Staff – Exhibit 100
Staff Recommendation
File No. EA-2024-0302

RECOMMENDATION

AMEREN TRANSMISSION COMPANY OF ILLINOIS

CASE NO. EA-2024-0302

Figure 3. Proposed Route DO-28 and DO-27⁷¹

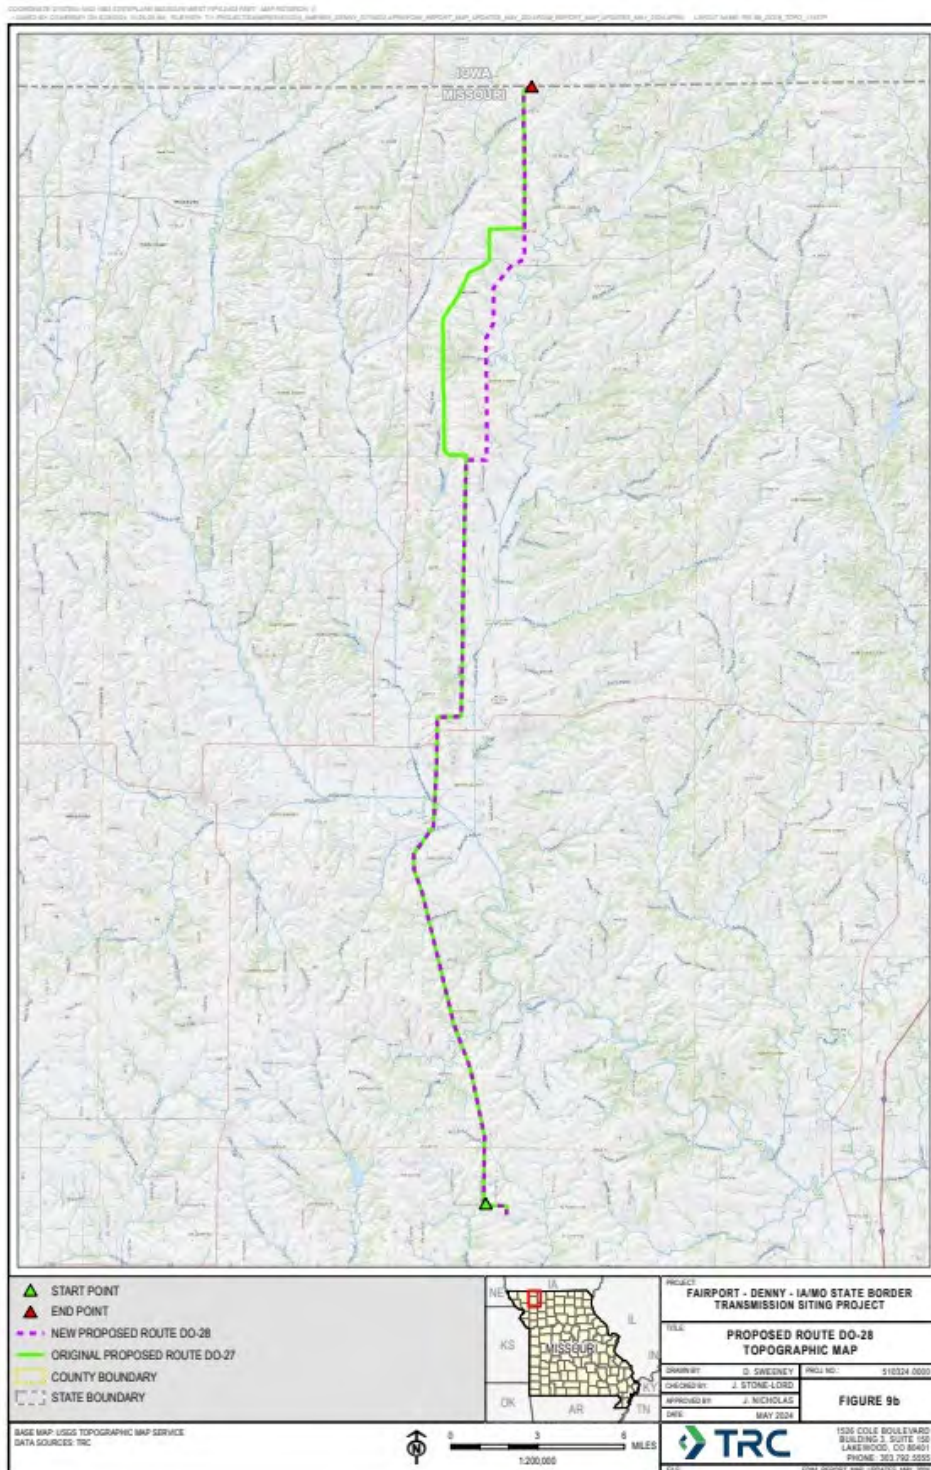
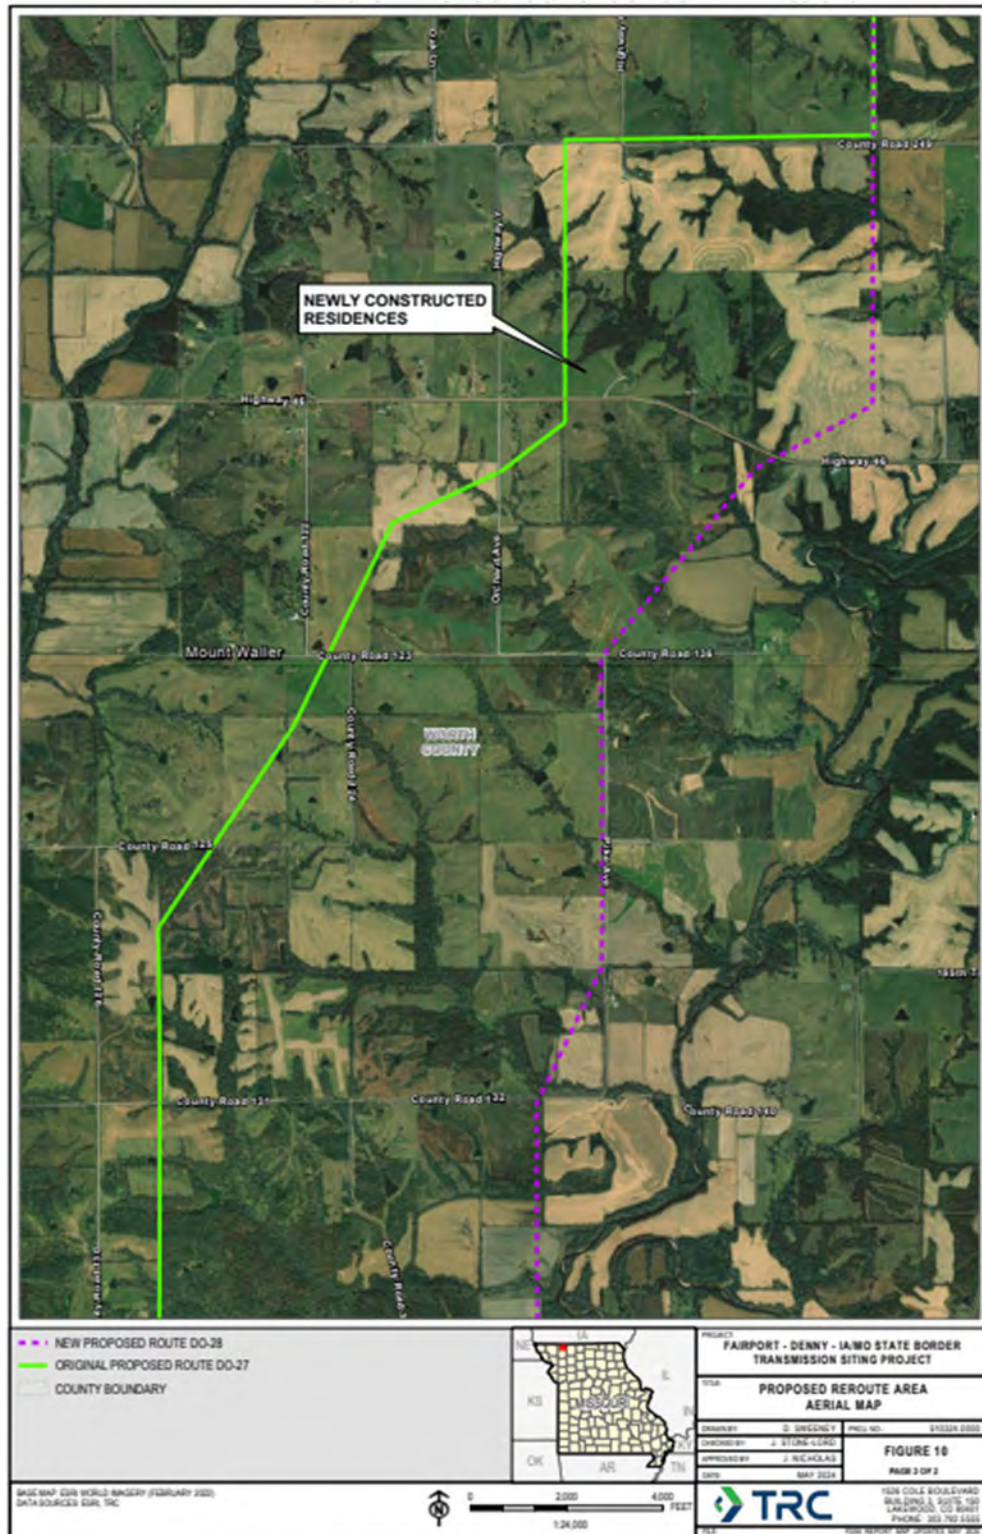
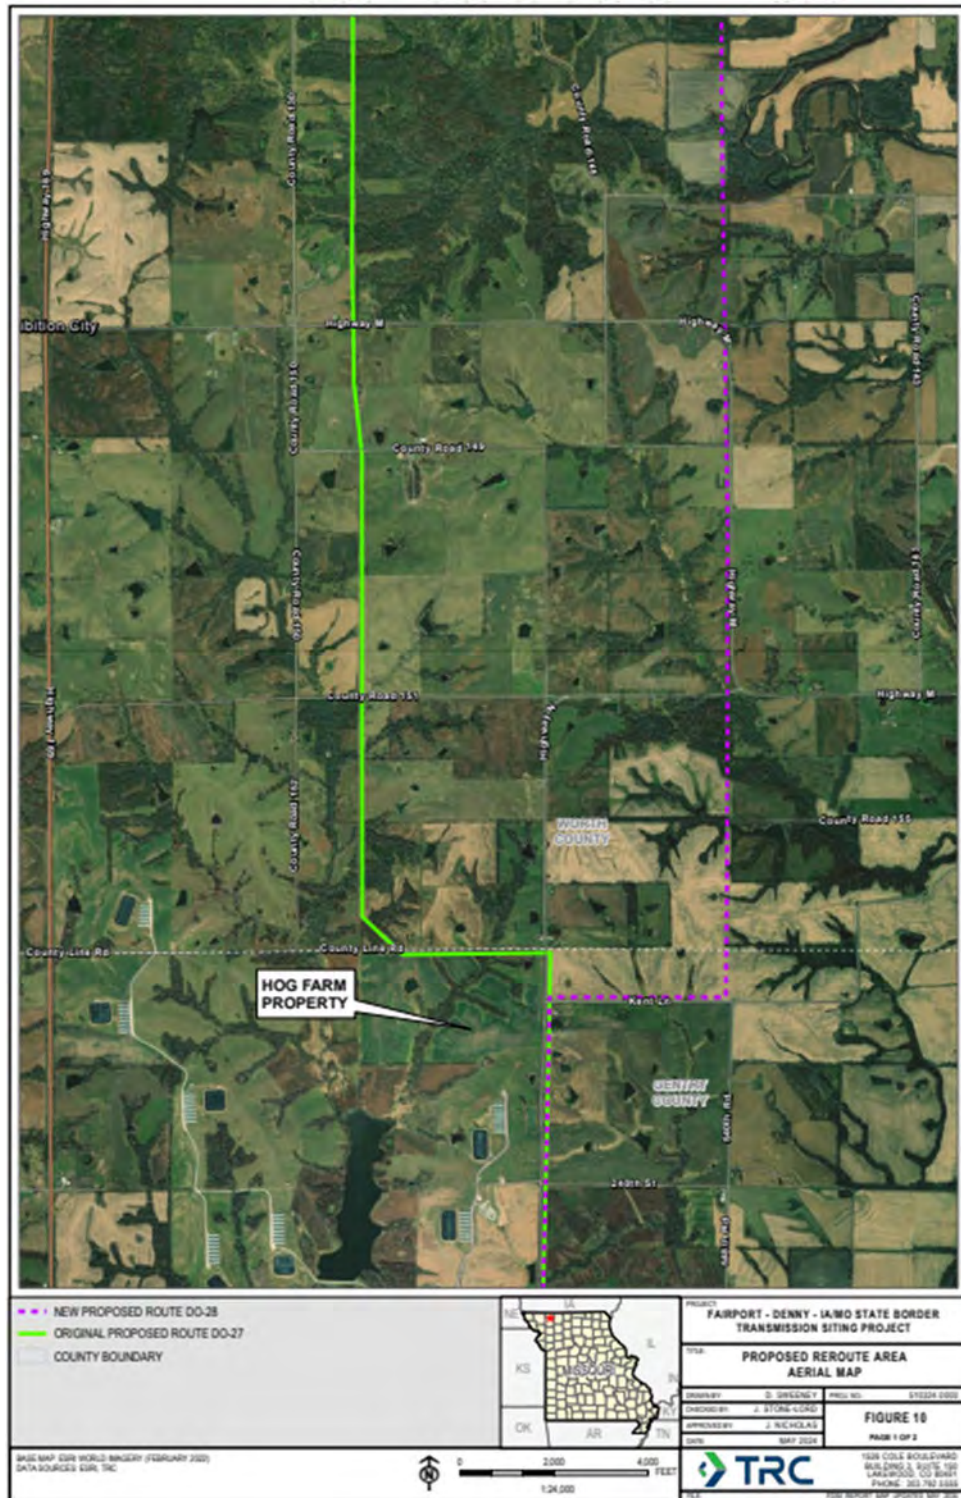
12 DO-27 was a route that was identified as having the overall best score in terms of suitability
13 of the first 27 routes considered. It is Staff's understanding that this route was part of the study
14 area presented at open public meetings hosted by ATXI.⁶⁸ However, as a result of ATXI's public
15 engagement DO-28 was identified.⁶⁹ ATXI represents DO-28 was selected as the proposed route
16 for the FDIM Project on or around May, 14, 2024.⁷⁰ Routes DO-28 and DO-27 are shown in
17 Figure 3. Figures 4 and 5 focus on the re-route area of DO-28 and DO-27 as this re-route area was
18 of significant concern to landowners during the Commission's LPHs.

1 ATXI asserts the routing of FDIM was changed as a result of ATXI's public outreach
2 efforts.⁷⁴ Originally, DO-27 was the most favorable route of the 27 routes originally considered,
3 but DO-28 is ATXI's proposed route in its application before the Commission. ATXI discusses
4 the route change in the Direct Testimony of James Nicolas and presents both routes in Schedule
5 JN-D1 (FDIM Route Selection Study, by TRC, dated July 2024). TRC provided three reasons for
6 the route change from DO-27 to DO-28:⁷⁵

As previously mentioned, ATXI did not provide notice of the CCN application to landowners along route DO-27. Staff views DO-27 as a known alternative route given that that ATXI discusses the re-route to DO-28 in its direct testimony, presents both options in the TRC routing study, and held open houses regarding a study area encompassing DO-27 and DO-28.⁹⁴ ATXI provided notice of the CCN to landowners within 300 feet of the proposed centerline, regardless of whether there is a structure, whereas the Commission rule requires notification of landowners whom an easement would be sought from and those whose habitable structures are within 300 feet.

During the virtual LPH, one individual questioned ATXI's re-route to the DO-28 alignment and proposed an alternative route.⁹⁵ Staff previously discussed the re-route on pages 31-32 of this Recommendation. DO-28 (the proposed route) is approximately 1 ½ miles east of DO-27 for approximately 9 ¼ miles.⁹⁶ Thus, if the Commission were to order ATXI to re-evaluate or return to the DO-27 alignment this may create additional frustration and confusion given the landowners along DO-27 were not identified by ATXI as affected landowners and did not receive notice of the CCN application when filed. A reasonable resolution would include additional opportunities for landowners associated with DO-27 to provide testimony to the Commission.
